ADDENDUM

PROJECT: Palmer Public Schools
Classroom Additions 2014
Palmer, Nebraska

AD-2

DATE ISSUED: Tuesday, January 13, 2015

From Sheet:	A-102	for CA use:
Drawing #	A-102.1

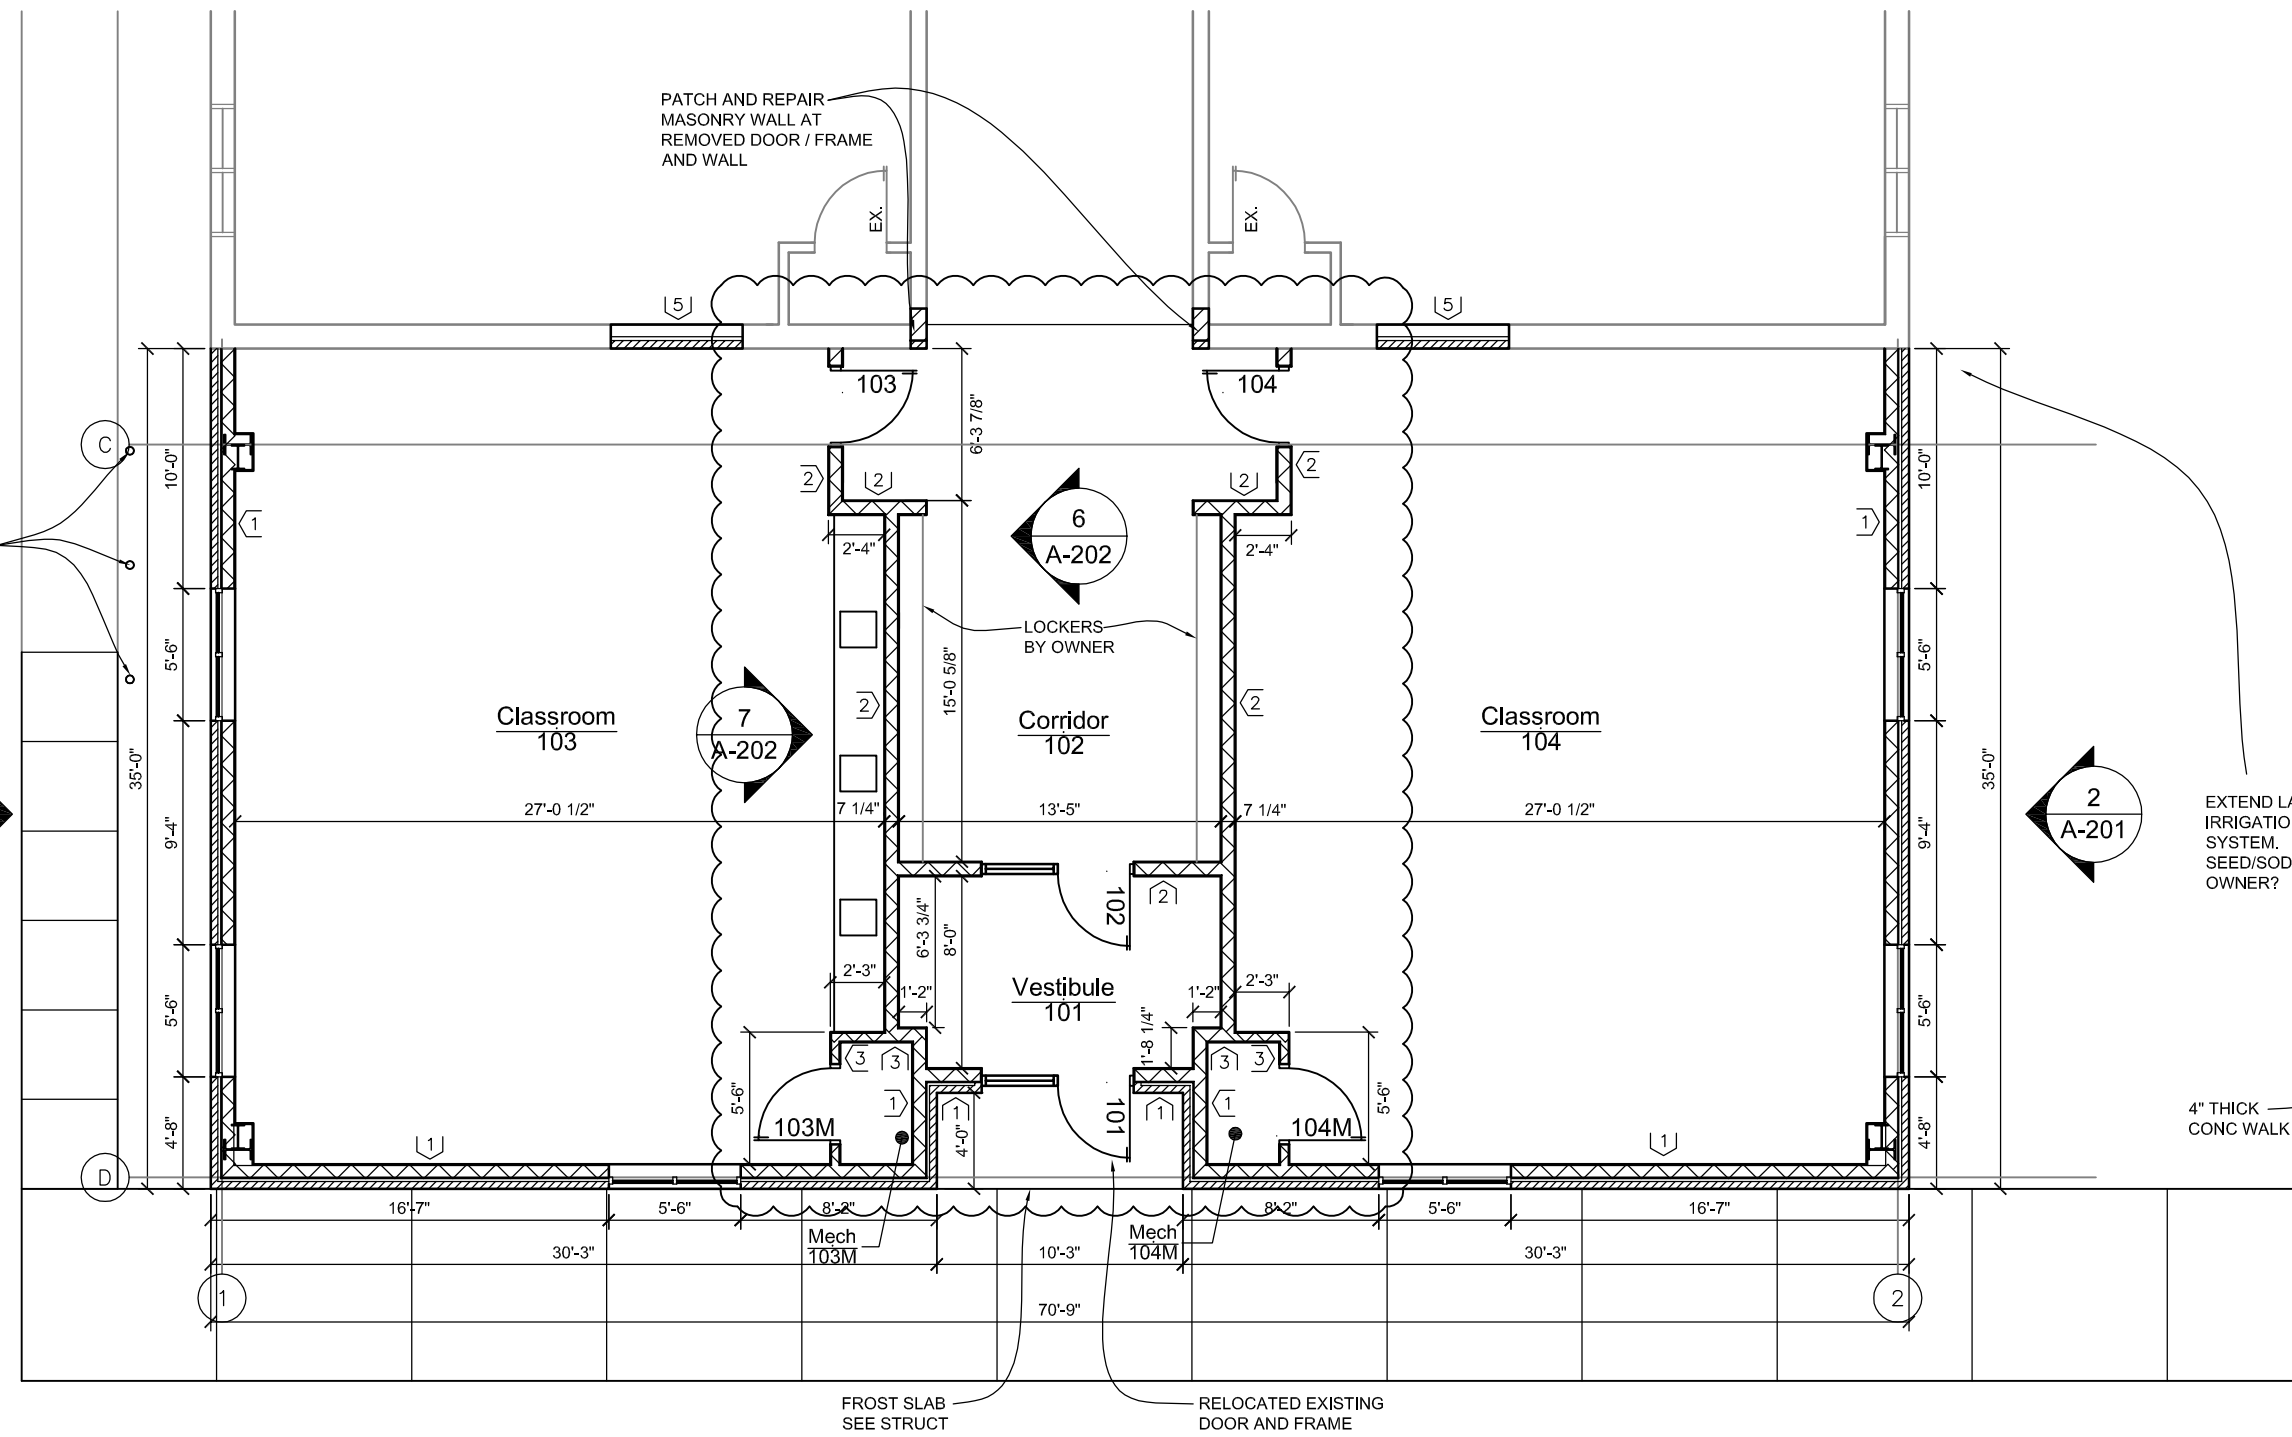
In reference to Sheet A-102, Area A Floor Plan, delete Fire Service Room 108. Re-locate Janitor's Closet 109 to other side of corridor, replacing one single toilet. See attached Supplemental Drawing A-102.1.

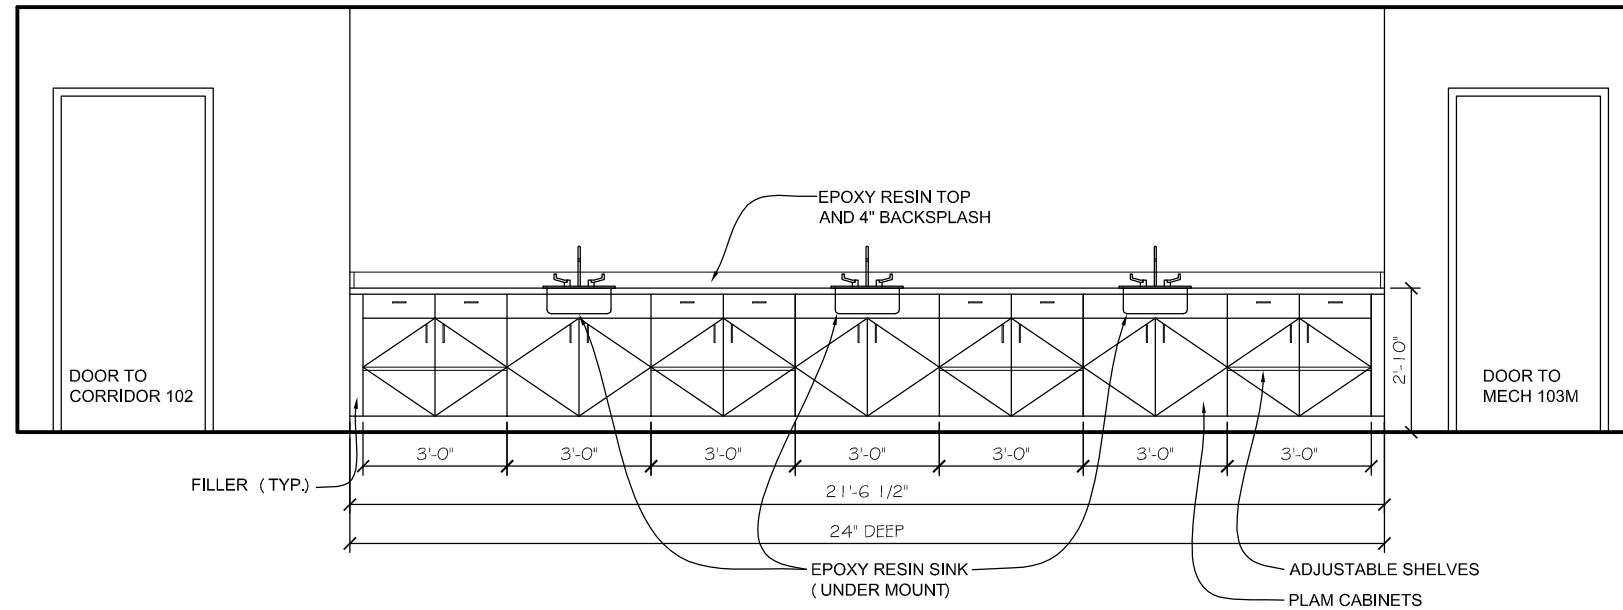
In reference to Sheet A-102, Area A Floor Plan, revise Corridor 102 layout to allow for future recessed student lockers. See attached Supplemental Drawing A-102.2.

In reference to Sheet A-202, Interior Elevations, add Elevation No. 7 for casework in Classroom 103. See attached Supplemental Drawing A-202.1.
